INTER-OFFICE MEMO

Item B.9: 7921-0051-00

Supplemental Information: Page Replacements

RE: **Agenda Item B.9, April 25, 2022, Regular Council – Land Use Agenda
Replacement Pages for Planning Report**

Drawing: Replacement Plan

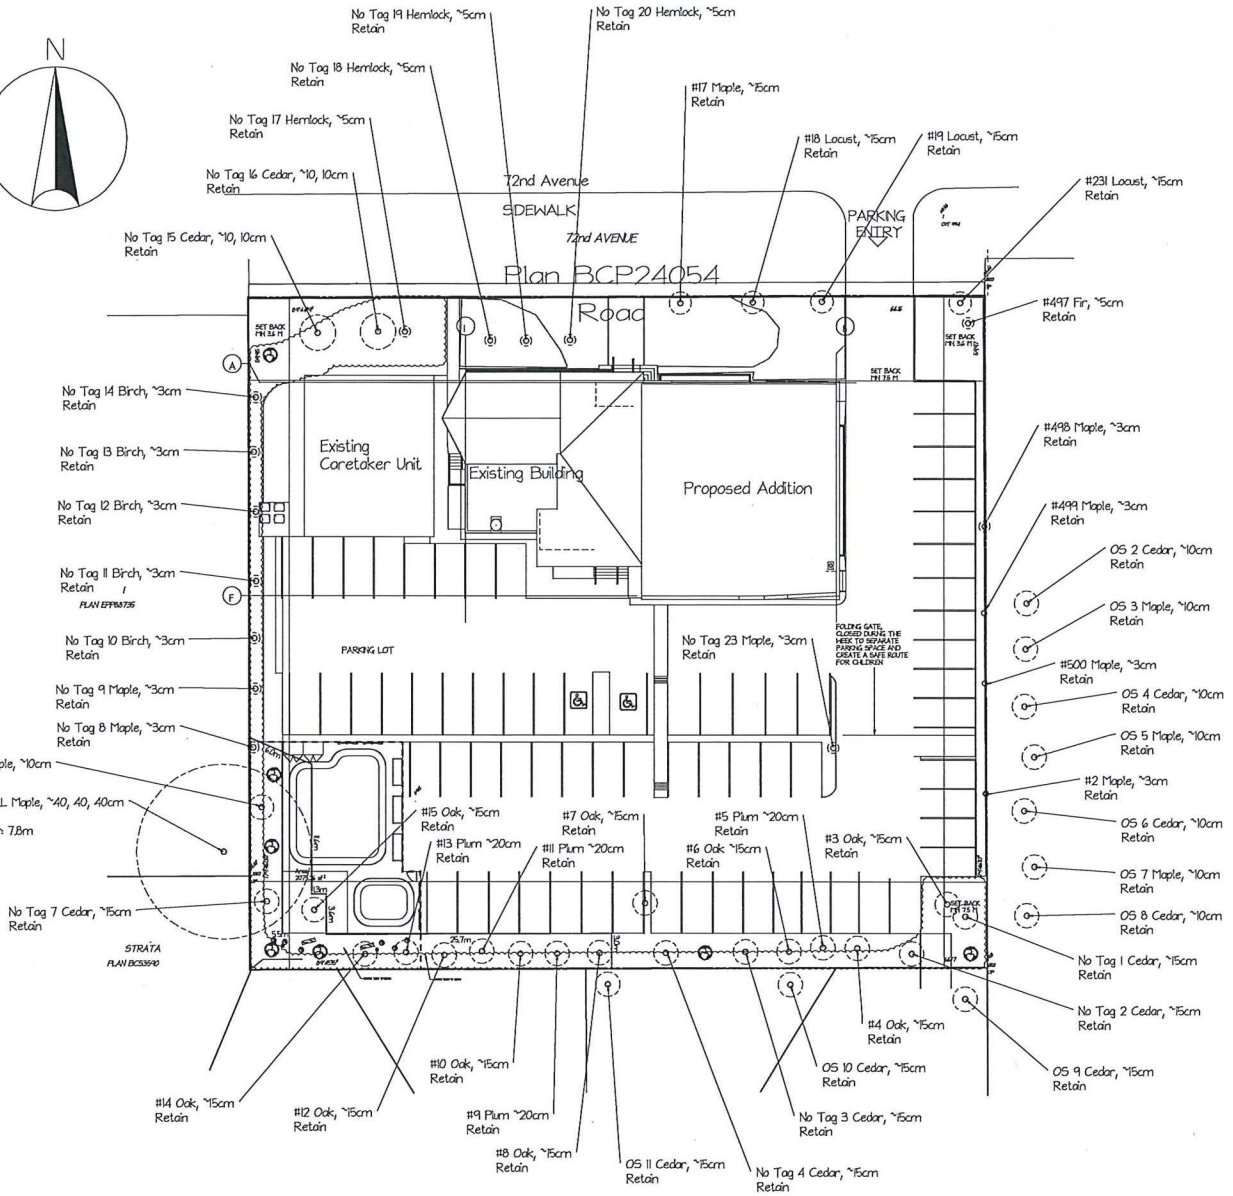
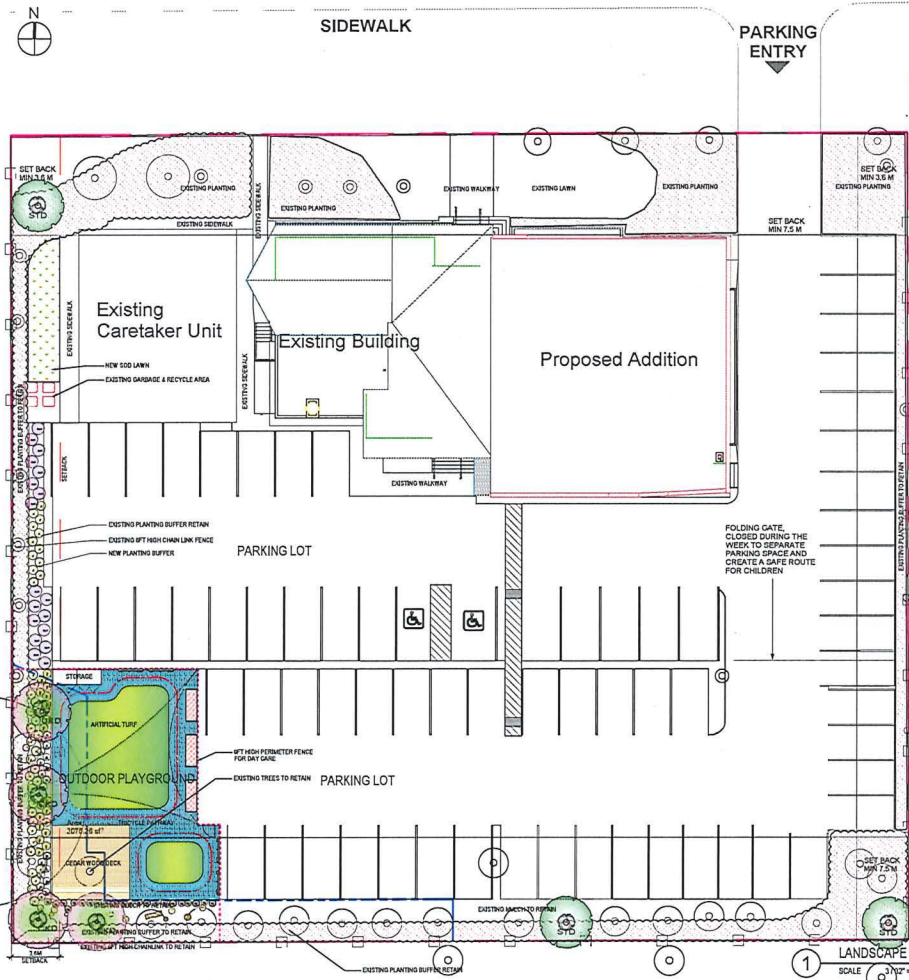
Additional information has been provided by the applicant pertaining to their tree management plan. The applicant is proposing to plant five additional trees than originally proposed. The “Trees” section, found on pages 9 and 10 have been updated by staff to more accurately reflect the proposed tree planting and contributions to the Green City Program. Appendix 3 and pages 5 – 7 of Appendix 4 (i.e. landscaping plans) have also been updated based on the additional information provided by the applicant.

- For those trees that cannot be retained, the applicant will be required to plant trees on a 2 to 1 replacement ratio. This will require a total of 10 replacement trees on the site. ~~The applicant is proposing to plant two replacement trees in the location of the two failing fir trees. The applicant is proposing to plant seven replacement trees throughout the site.~~ As only ~~two~~ seven replacement trees can be accommodated on the site there is a deficit of ~~8~~ three replacement trees that will require a cash-in-lieu of replacement payment of ~~\$4,400~~ \$1,650 (\$550 per tree), to the Green City Program, in accordance with City’s Tree Protection By-law.

- In summary, a total of ~~44~~ 49 trees are proposed to be retained or replaced on the site with a contribution of ~~\$4,400~~ \$1,650 to the Green City Program.
